Peach Bottom Atomic Power Station, Units 2 & 3  
Facility Operating License Nos. DPR-44 and DPR-56  
NRC Docket Nos. 50-277 and 50-278

Subject: License Amendment Request 01-01190  
Power Uprate Request for Appendix K Measurement Uncertainty Recapture

License Amendment Request (LAR) 01-01190  
"PBAPS Measurement Uncertainty Recapture Power Uprate"

**SAFETY ANALYSIS REPORT  
FOR  
PEACH BOTTOM ATOMIC POWER STATION  
UNITS 2 & 3  
THERMAL POWER OPTIMIZATION**

Figure 3.4.1-1 (page 1 of 1)

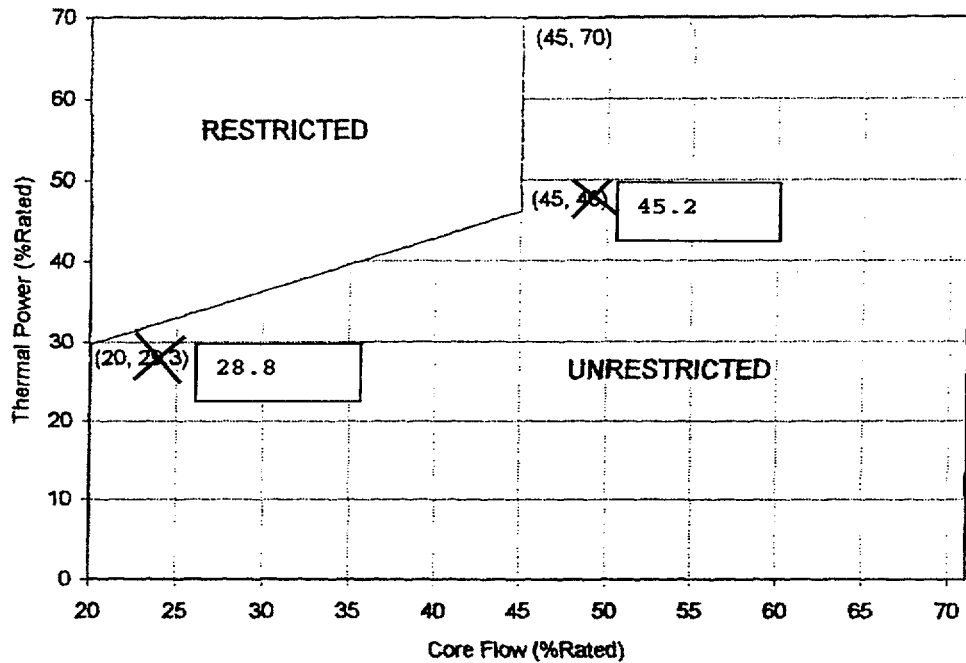
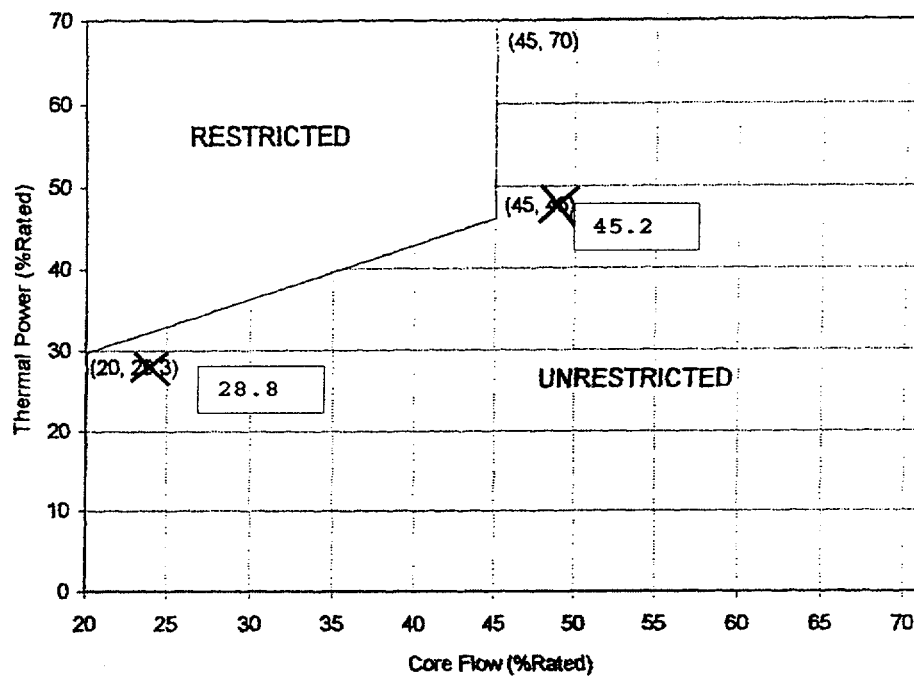
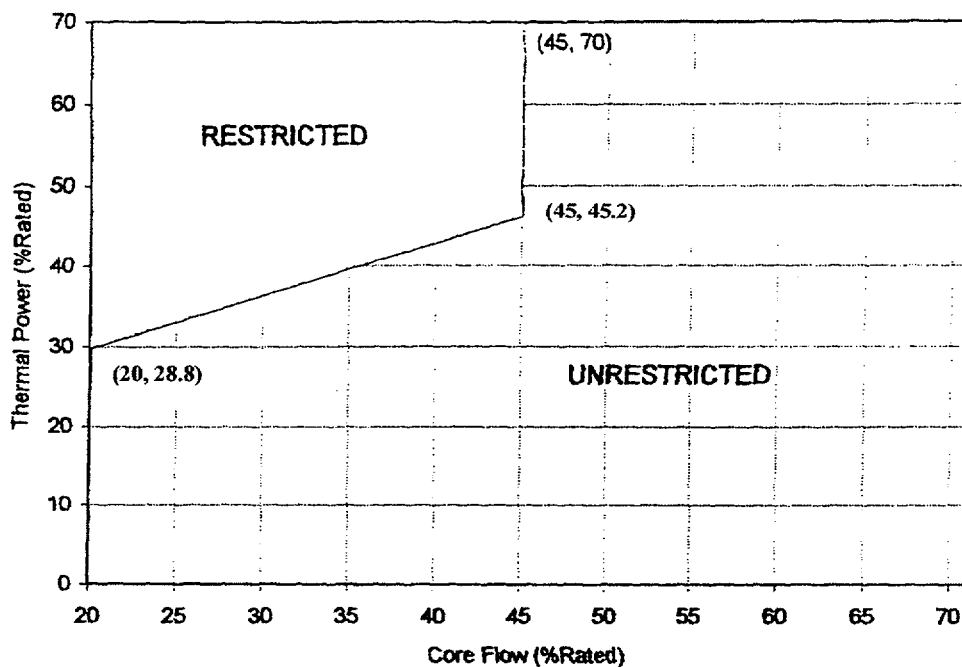
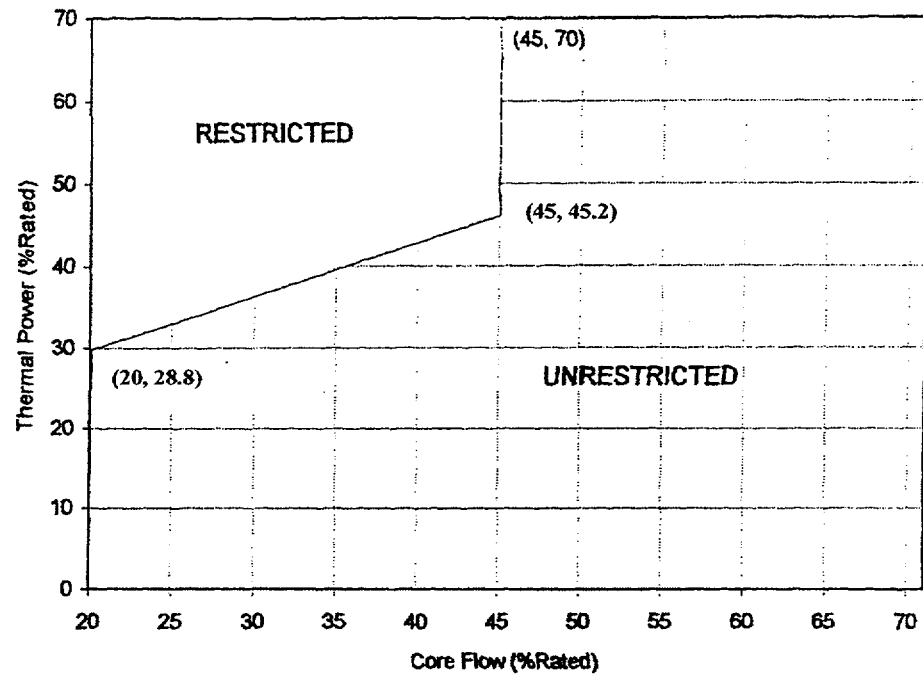
6. The percentage RTP is revised to "29.5" from "30" in TS SR 3.3.1.1.13.
7. The percentage RTP is revised to "29.5" from "30" in TS 3.3.4.2 Applicability, Required Action C.2, and SR 3.3.4.2.4.
8. Figure 3.4.1-1, Thermal Power Versus Core Flow Stability Regions, is replaced.

Proposed change 8 replaces the "Thermal Power Versus Core Flow Stability Regions" map with one rescaled to reflect the new 100% power level of 3514 MWt.
